Item ID: D206-642-341BL

Item Name: Replacement Skidtube (Fits LH or RH)

DRAWING NO. D2650	TITLE 206/407 SKIDTUBE ASSEMBLIES	REV. F	DART AEROSPACE LTD ENGINEERING ORDER		D.E.O. NO. D2650-F-1	SHEET NO. SHEET 1 OF 1	SCALE NTS
DRAWN <i>[Signature]</i>	CHECKED A.P.	MFG. APPR. <i>[Signature]</i>	APPROVED <i>[Signature]</i>		DE APPR. <i>[Signature]</i>		
DATE 12.10.12	DATE 12.10.22	DATE 12.10.22	DATE 12.10.22		DATE 12.10.22

CHANGE C'BORED WELDED CROSSBOLT SPACERS TO SWAGED SPACERS

DETAIL D
FOR Ø0.375 HOLES ONLY
SCALE 3X

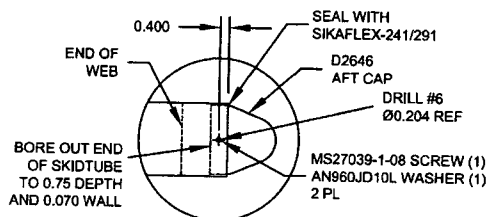
ADD DETAIL G BELOW, WHICH IS THE SAME SECTION VIEW AS DETAIL D OF DWG.
C'BORED HOLES ARE **NOW SWAGED** PER DETAIL G BELOW. FOR THE Ø0.375 HOLE THAT IS NOT C'BORED, WELD PER DETAIL D OF DWG (SEE AMENDED DETAIL B FOR REFERENCE).
